# UNITED STATES PATENT AND TRADEMARK OFFICE

APPLICATION NO.	FILING DATE	FIRST NAMED INVENTOR	ATTORNEY DOCKET NO.	CONFIRMATION NO.
10/707,134	11/21/2003	Michael Marx	9091-000002/US	1133
27572	7590	11/24/2006		
HARNESS, DICKEY & PIERCE, P.L.C. P.O. BOX 828 BLOOMFIELD HILLS, MI 48303			EXAMINER GABLER, PHILIP FRANCIS	
			ART UNIT	PAPER NUMBER
			3637

<b>Office Action Summary</b>	Application No. 10/707,134	Applicant(s) MARX, MICHAEL	
	Examiner Philip Gabler	Art Unit 3637

## DETAILED ACTION

Morghen '588 Figures 1-4

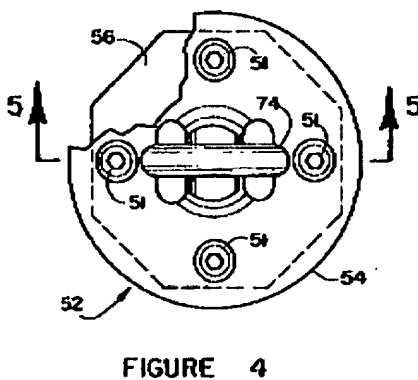
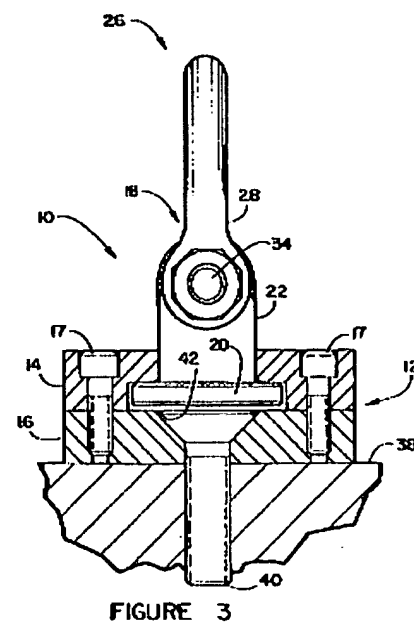
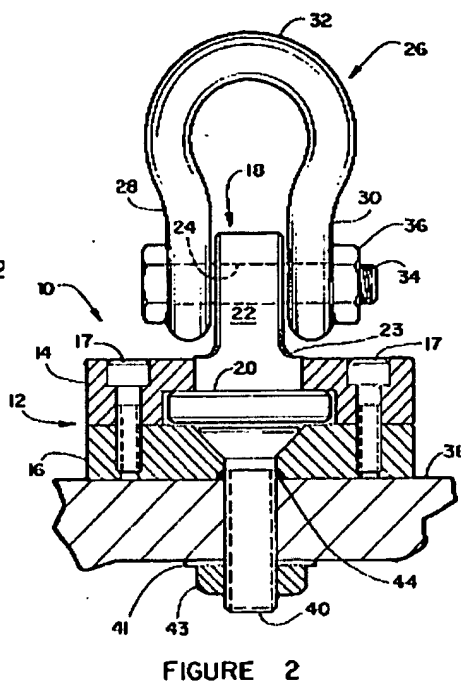
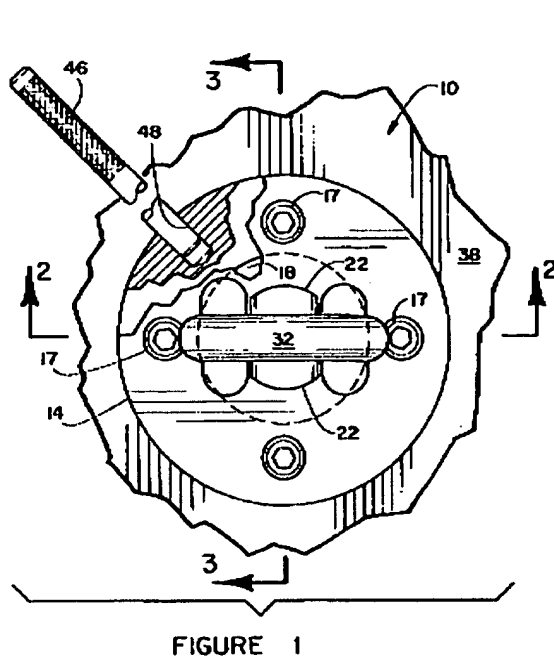
2. Claims 8, 12, 15-20, and 25-35 are rejected under 35 U.S.C. 102(b) as being anticipated by Morghen (US Patent Number 5823588).

3. Regarding claims 8, 12, 15, 16, and 20, Morghen discloses an anchor device (10) for coupling an external device to a surface of a deck (38), said anchor device being received within an opening (through which element 40 passes) of the surface, said opening having an edge of the surface therein, said anchor device comprising: an anchor body (12, including 26, 40, 43, etc.) comprising a first body portion (16, 40, etc.) and a second body portion (14, 18, etc.), said anchor body positioned at least partially within said opening so that a fixed-dimension notch (viewed as the notch formed by 16, 40 and 41, and fixed in dimension in as much as Applicant's notch is) in the first body portion receives the edge of the surface, said second body portion comprising a coupler (22, 26) extending outward from the opening, said coupler capable of coupling to an external device, the first body portion having a first planar member (16) extending parallel to said surface, said coupler extending in a direction perpendicular to said first planar member, said anchor body having a flange (20) fixedly coupled to said first

4. Regarding claims 17-19, Morghen further discloses the second planar member has a first length (in the longitudinal direction) greater than an opening length and a first width (in the lateral direction) greater than an opening width (the opening length and width being the equivalent, longitudinal and lateral, measures of the opening).

5. Regarding claims 26 and 27, Morghen discloses an anchor device (10) for coupling an external device to a surface of a deck (38), said anchor device being received within an opening (through which element 40 passes) of the surface, said opening having an edge of the surface therein, said anchor device comprising: a first body portion (16, 40, etc.) having a longitudinal side (Figure 2) and a lateral side (Figure 3), said first body portion positioned at least partially within said opening so that a fixed-dimension notch (viewed as the notch formed by 16, 40 and 41, and fixed in dimension in as much as Applicant's notch is) formed in the lateral side receives the edge of the surface and partially positioned on said surface over said opening and a first member (16) positioned over the opening to engage a top surface of the deck; and a second body portion (14, 18, etc.), having a coupler (22, 26) extending outward from the first body portion, said coupler capable of coupling to an external device, the second body

6. Regarding claim 25, Morghen further discloses the notch comprises a generally U-shape notch (see figures).

7. Regarding claims 28 and 29, Morghen further discloses the second body portion is fixedly coupled to the first body portion (via elements 17) forming a unitary structure.

8. Regarding claim 30, Morghen further discloses a flange (20) fixedly coupled to said first body member (via the second body portion) and said coupler.

9. Regarding claims 31 and 32, Morghen further discloses said first body portion further comprises an extension portion (17) having a circular shape, said extension portion extending into said second body portion.

10. Regarding claims 33 and 34, Morghen further discloses said second body portion comprises a first planar member (23) extending parallel to the surface and a second planar member (14) coupled to said first body portion and sized greater than said opening.

11. Regarding claim 35, Morghen further discloses the second body portion comprises a channel (through which 17 passes) therethrough for receiving a fastener (17), said fastener coupling said first body portion and said second body portion.

37. Regarding claim 3, Morghen (Figures 1-3) discloses an anchor device (10) for coupling an external device to a surface of a deck (38), said anchor device being received within an opening (through which element 40 passes) of the surface, said opening having an edge of the surface therein, said anchor device comprising: an anchor body (12, including 26, 40, 43, etc.) having a longitudinal side (Figure 2) and a lateral side (Figure 3), said anchor body positioned at least partially within said opening so that a fixed-dimension notch (viewed as the notch formed by 16, 40 and 41, and fixed in dimension in as much as Applicant's notch is) formed in the lateral side receives the edge of the surface, said anchor body comprising a coupler (22, 26) extending outward from the opening, said coupler capable of coupling to an external device. [While a specific external device is not disclosed, such a device (e.g. a hook) is inherent in the operation of the invention.] Morghen does not disclose an anchor body having a rectangular shape. Varying the shape of a body is well known in the art however, as shown by Morghen, who discloses both round and octagonal (see for example Figure 4) anchor body shapes. Accordingly, it would have been obvious to one of ordinary skill in

38. Regarding claim 2, Morghen further discloses the notch comprises a generally U-shape notch (see figures).

39. Regarding claim 4, Morghen further discloses the coupler comprises a first coupler (22) and a second coupler (26).

40. Regarding claim 5, Morghen further discloses said first coupler and said second couple have a respective first coupling hole (24) and a second coupling hole (aperture of 28) therethrough.

42. Regarding claim 7, Morghen further discloses the anchor body comprises a first body portion (14, 18, etc.) and a second body portion (16, 40, etc.), said first body portion having the coupler and said second body comprising said notch.

47. Regarding claim 22, Morghen further discloses a fastener plate (41) coupled to the second body portion.

Celette '236 Figures 1, 2, and 4

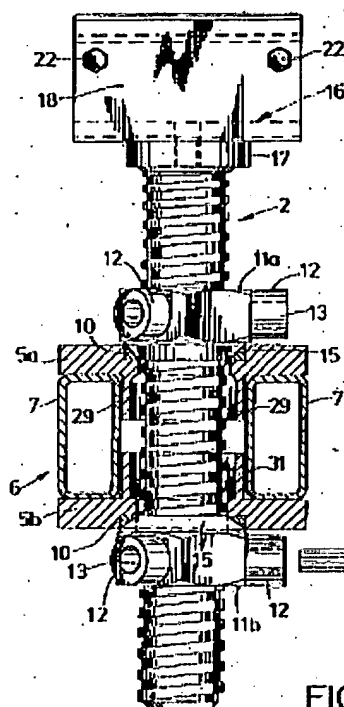
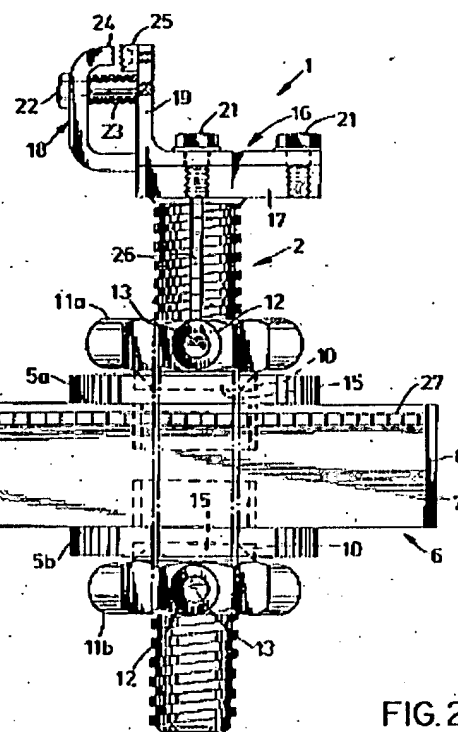
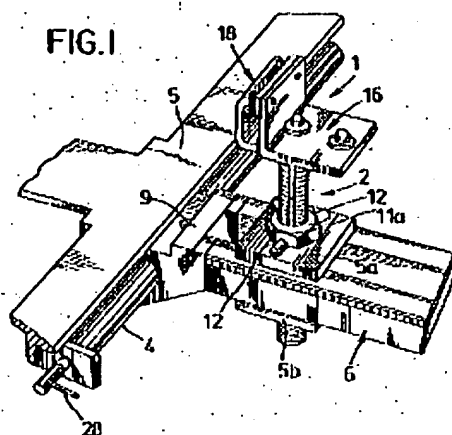
12. Claims 2-18, 20-23, 25-35, and 51 are rejected under 35 U.S.C. 102(b) as being anticipated by Celette (US Patent Number 4519236).
13. Regarding claim 3, Celette (Figures 1, 2, and 4) discloses an anchor device (1, 2, 5, 14, etc.) for coupling an external device to a surface of a deck (6), said anchor device

being received within an opening (between elements 7 of 6) of the surface, said opening having an edge of the surface therein, said anchor device comprising: an anchor body (1, 2, 5, including 16, etc.) having a rectangular shape (various components of the anchor are rectangular, and its form is generally rectangular) with a longitudinal side (on left of Figure 1) and a lateral side (side seen in Figure 2), said anchor body positioned at least partially within said opening so that a fixed-dimension notch (viewed as the notch formed by elements 5a and 5b, and fixed in dimension in as much as Applicant's notch is) formed in the lateral side receives the edge of the surface, said anchor body comprising a coupler (formed by 16 and 18) extending outward from the opening, said coupler capable of coupling to an external device (for instance a vehicle body, not shown, but described in column 3 lines 16-21).

14. Regarding claim 2, Celette further discloses the notch comprises a generally U-shape notch (see figures).

15. Regarding claim 4, Celette further discloses the coupler comprises a first coupler (19 of 16) and a second coupler (18).

18. Regarding claim 7, Celette further discloses the anchor body comprises a first body portion (1) and a second body portion (5a, 5b, etc.), said first body portion having the coupler and said second body comprising said notch.

body portion (1), said anchor body positioned at least partially within said opening so that a fixed-dimension notch (viewed as the notch formed by elements 5a and 5b, and fixed in dimension in as much as Applicant's notch is) in the first body portion receives the edge of the surface, said second body portion comprising a coupler (formed by 16 and 18) extending outward from the opening, said coupler capable of coupling to an external device, the first body portion having a first planar member (horizontal member of 5a) extending parallel to said surface, said coupler extending in a direction perpendicular to said first planar member, said anchor body having a flange (17) fixedly coupled to said first planar member (via element 2) and said coupler, the second body portion being rotatably coupled to the first body portion and having a second planar member (horizontal member of 16) disposed parallel to the surface, coupled to the first planar member (via element 2), and sized greater than said opening (at least in one dimension). [Note that while a specific external device is not shown, a vehicle body is described in column 3 lines 16-21 as being engaged by the coupler.]

notch formed by elements 5a and 5b) receives the edge of the surface, said anchor body comprising a coupler (formed by 16 and 18) extending outward from the opening, said coupler capable of coupling to an external device, said coupler being trapezoidally-shaped (elements 18 and 19 both have trapezoidal shape, see Figure 4). [Note that while a specific external device is not shown, a vehicle body is described in column 3 lines 16-21 as being engaged by the coupler.]

30. Regarding claim 30, Celette further discloses a flange (17) fixedly coupled to said first body member (via element 2) and said coupler.

32. Regarding claims 33 and 34, Celette further discloses said second body portion comprises a first planar member (lower horizontal portion of 18) extending parallel to the surface and a second planar member (horizontal member of 16) coupled to said first body portion (via element 2) and sized greater than said opening (at least in one dimension).

33. Regarding claim 35, Celette further discloses the second body portion comprises a channel (through which 21 passes) therethrough for receiving a fastener (21), said fastener coupling said first body portion and said second body portion (via element 2).

comprising a first body portion (5a, 5b, etc.) and a second body portion (1, etc.), said anchor body positioned at least partially within said opening so that a notch (in element 5b) in the first body portion receives the edge of the deck, said first body portion having a unitary structure (in that the elements are connected; 5a and 5b connected by 2, for example) including a first planar member (horizontal member of 5a) disposed adjacent to an upper surface of the deck and having at least one dimension larger than the opening, and a second planar member (5b) having the notch formed therein, said second planar member extending adjacent to the edge and a lower surface of the deck, said second body portion comprising a coupler (formed by 16 and 18) extending outward from the opening, said coupler capable of coupling to an external device. [Note that while a specific external device is not shown, a vehicle body is described in column 3 lines 16-21 as being engaged by the coupler.]

49. The remainder Applicant's arguments filed 4 October have been fully considered but they are not persuasive. The use of the term "fixed-dimension" in relation to the notch is not viewed as distinguishing over the prior art. The dimensions of Applicant's notch appear to be fixed only by a threaded fastener (elements 76 and 80) in very much the same way that the dimensions of notches in the cited references are. Like Applicant's notch, the notches of the prior art will be fixed so long as the fastener is tightened and held stationary. Further, it is noted that the Celette reference does in fact disclose a coupler that can be considered trapezoidally shaped. The definition of a

trapezoid simply requires two sides of a four-sided shape to be parallel, a limitation that is clearly met by Celette's coupler. Finally, the word "unitary" does not in itself require one-piece construction, only that the parts comprise a unit.
